PLANNING COMMISSION AGENDA
Monday, October 30, 2023 at 6:00 p.m.
Caledonia Village Hall – 5043 Chester Lane

Re: Land Use Amendment, Rezoning, and Site Plan Review Request
Adams Road Elevated Storage Tank and Water Main Extension
Tax Key No. 104-04-22-30-015-224

Proposal: Building, Site, and Operation Plan Review

Exhibit A

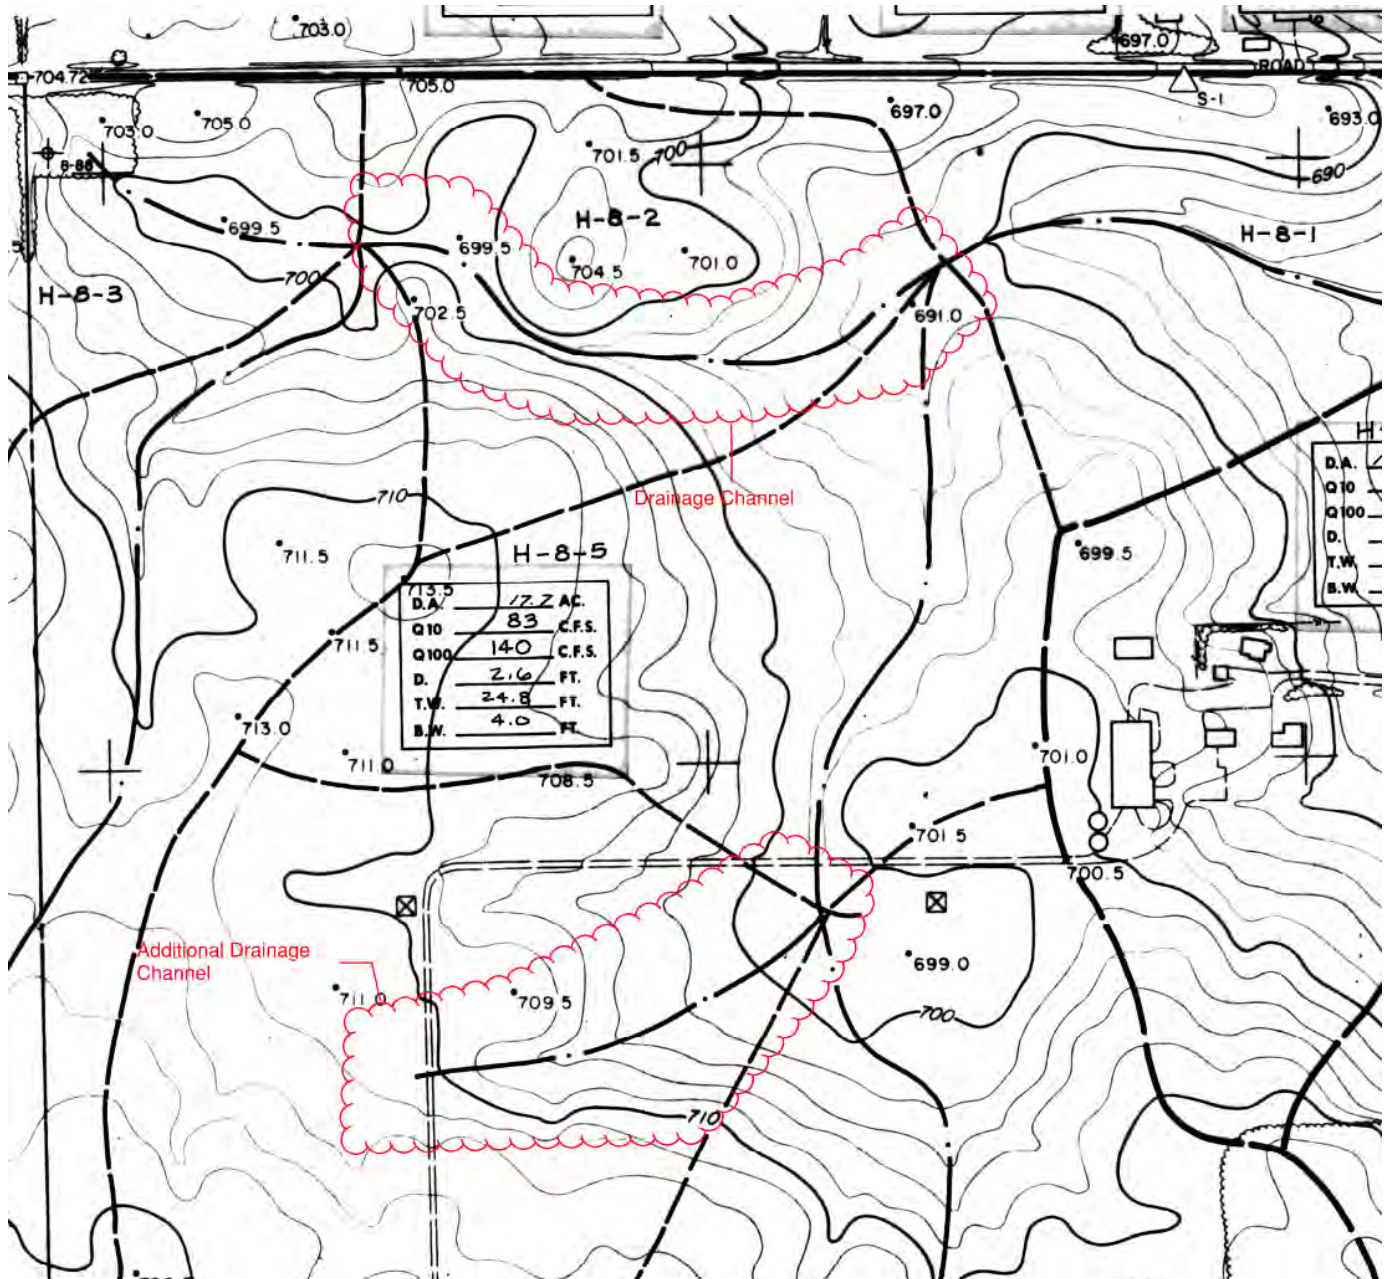
This Concept CSM is for the creation of 2 lots on the parcel. It is proposed that lots 1 and 2 will be divided nearly equally on the parcel to create a 9.9-acre parcel and a 10.1-acre parcel. Only one shared driveway access is allowed and the CSM would require 45' to be dedicated to the public for Right-of-Way purposes. The current driveway located on the far west side of the property would need to be abandoned if new access was desired. If additional accesses are requested (one per newly created parcel), a modification waiver would need to be approved at the Final CSM.

The drainage of the CSM, according to the Master Drainage Plan, shows the primary watershed (H-8-2) with a channel cutting through the lot. A 40' wide Drainage Easement will be required on the lots over the primary drainage channel as laid out on the Master Drainage Plan included in Exhibit A. The CSM due east of this parcel included a 100' wide easement for the downstream portion but will only need to be 40' wide on this proposed land split. In addition, watershed H-8-6 includes a small portion of a drainage swale at the south side of the property. This drainage way will require a 30' easement which runs north by northeast through the two parcels before tying into the primary channel from H-8-2. The easements are required to be centered on the

There is a low spot in the Northwest corner of the parcel that shall be accounted for in the survey of the property to determine if the drainage channel needs to extend north to collect this area. This low spot may overlap with the wetland delineation. The surveyor shall provide enough information on the CSM to represent this area and determine if the Village will require an extension of the easement to accommodate the low point or provide a solution to drain it properly.

Waiver/Modification Request #1 will directly affect both parcels as the existing lot is approximately 1764.95 feet long by 496.89 feet wide (which already exceeds the ratio). To properly divide the land, each parcel will be approximately 250' x 1,765' which will require the modification waiver.

6. **The Final CSM dedicates 45' for public road purposes. A note shall be provided stating as such on the Final CSM.**
7. **The Surveyor locates the drainage channels in coordination with the Village provided Master Drainage Plan and shows it on the CSM.**

8. **The Owner provides a 40' storm water drainage easement over the drainage channel on the north section of the property and a 30' drainage easement on the south end of the property. These shall be shown on the CSM. A separate exhibit may be required to provide detail and clarity.**

10. **The Zoning Requirements for A-2 Zoning are written and displayed on the CSM (setbacks, etc.).**
11. **Locate and display a cross access and maintenance agreement on the Final CSM for both properties. The original parcel is limited to one shared access or a Modification Waiver will be required to create individual access to each newly created lot.**

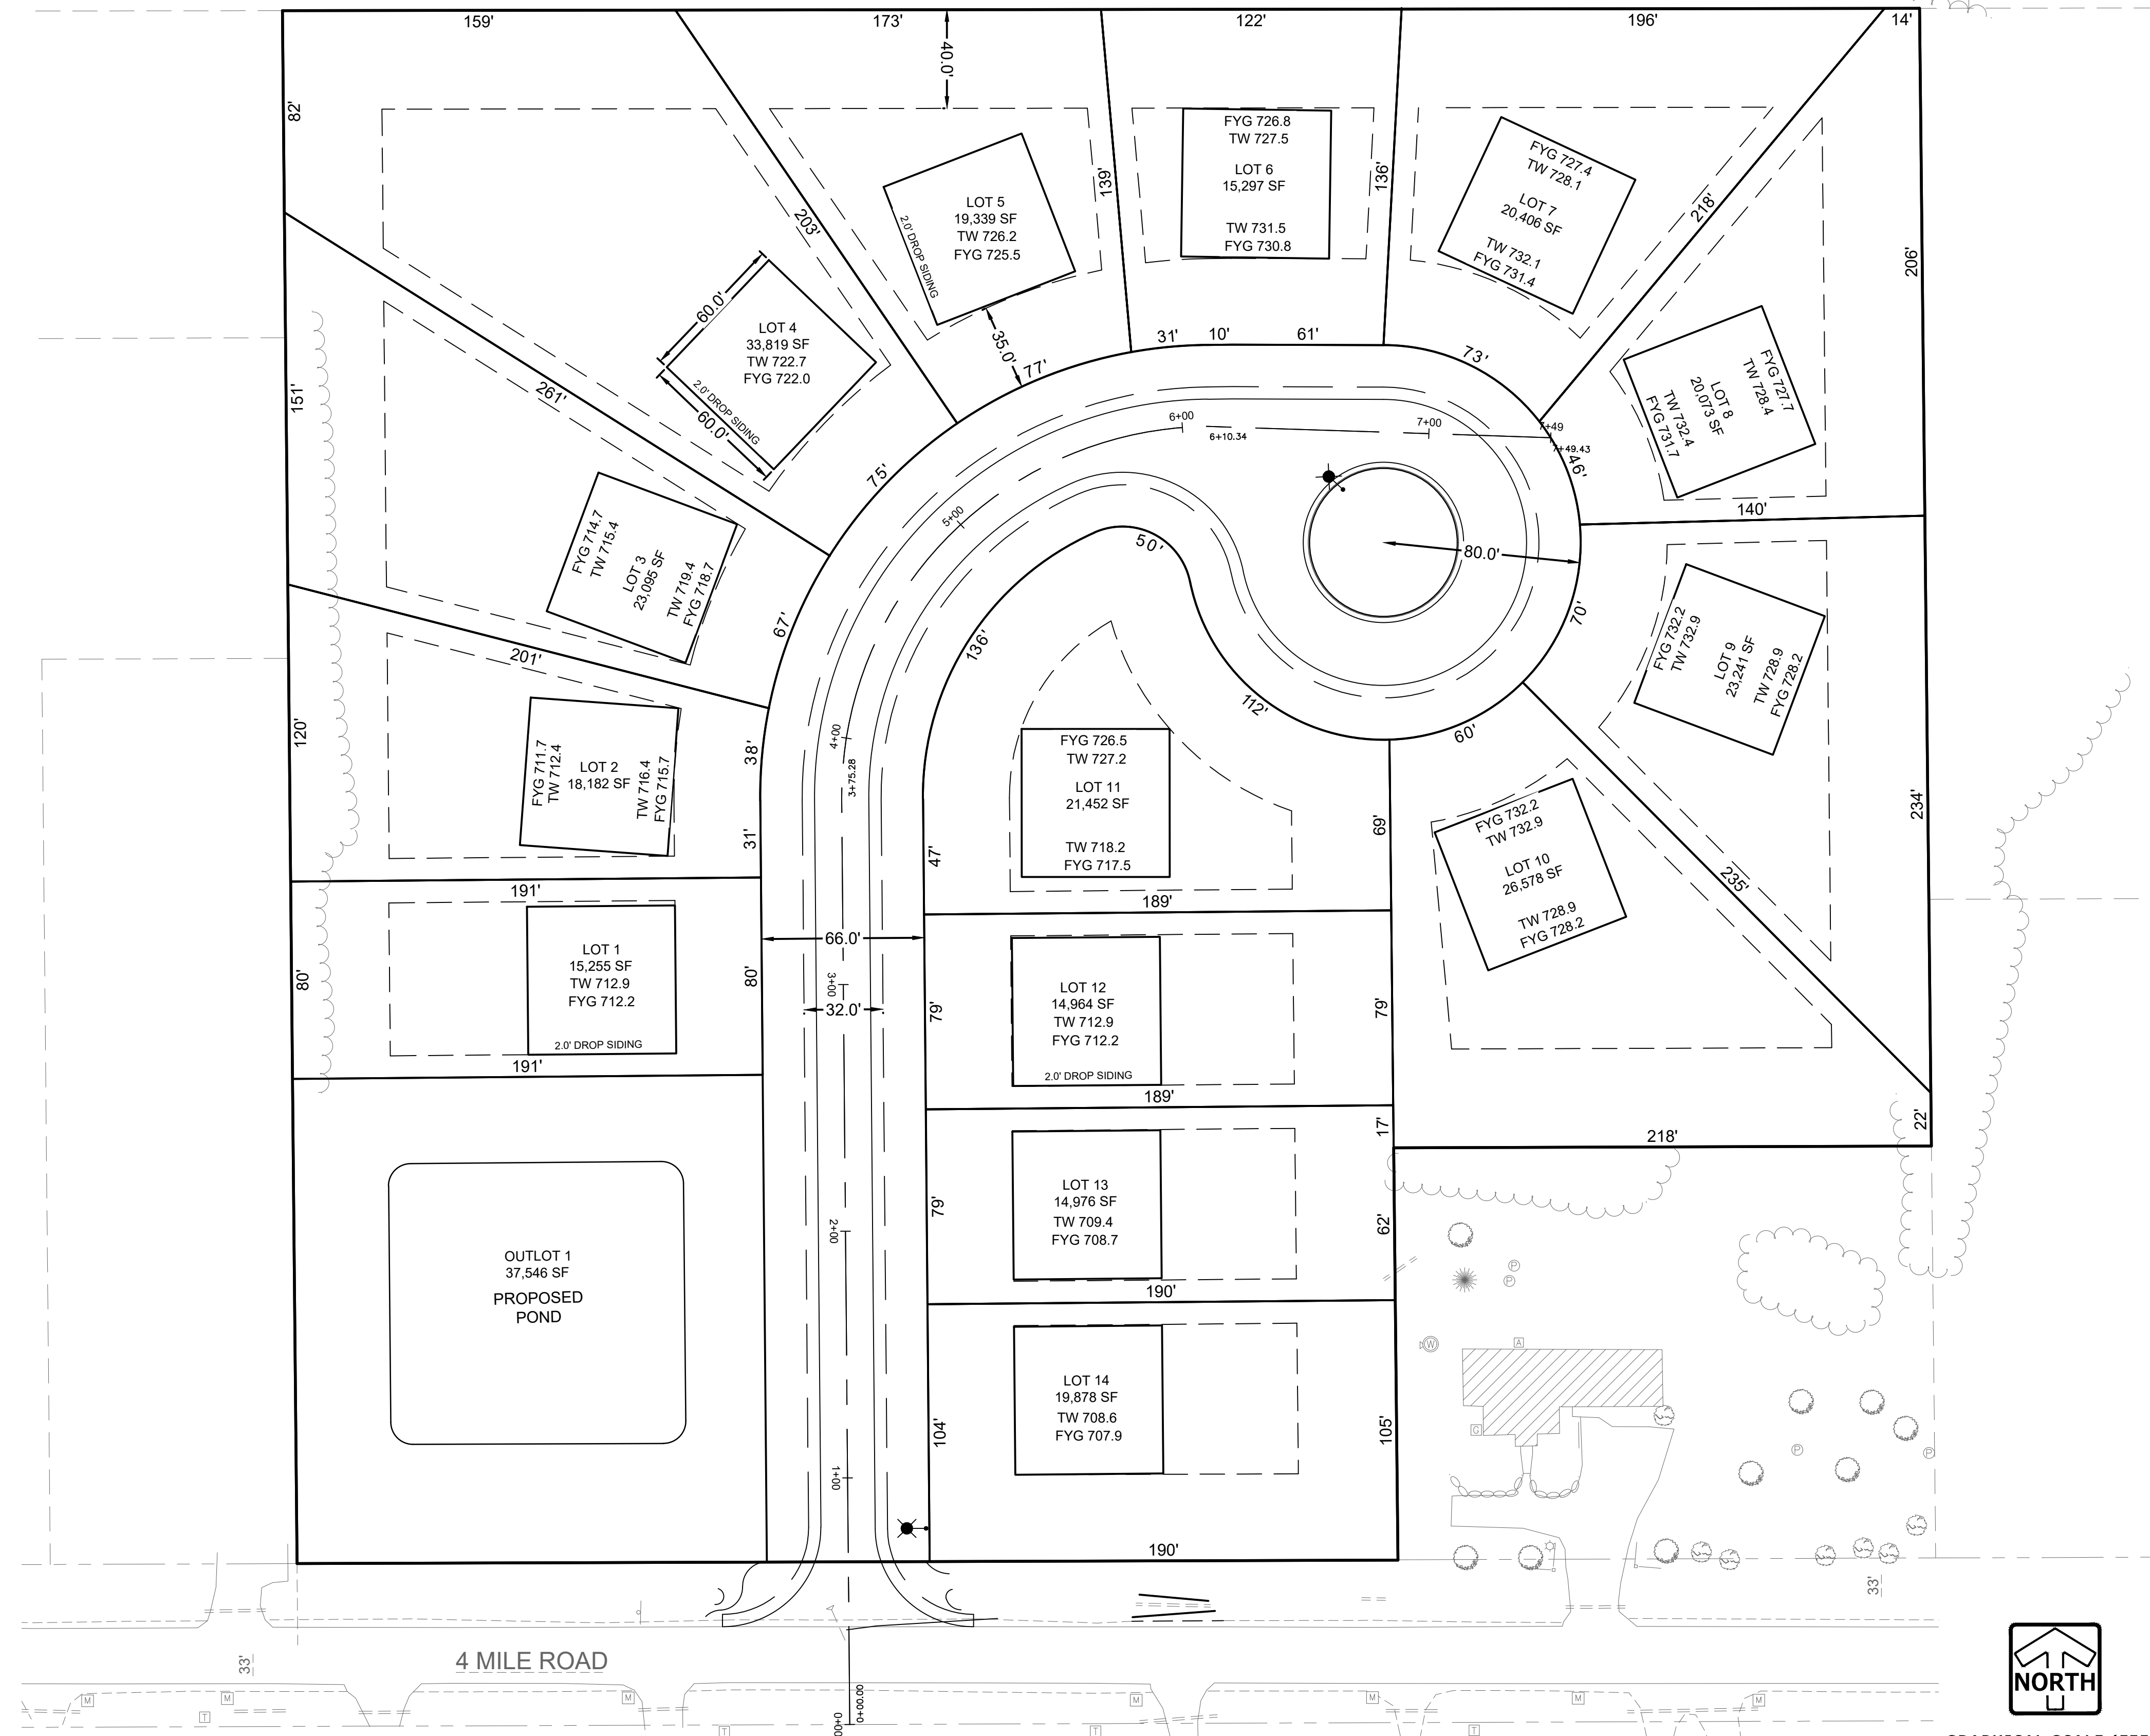
In regards to Waiver/Modification request #1, the Concept Plan is proposing 8.5% open space. This does not meet the 40% requirement, but it is in the sanitary sewer service area and the Village is in the process of eliminating the open space requirement in the sanitary sewer service area.
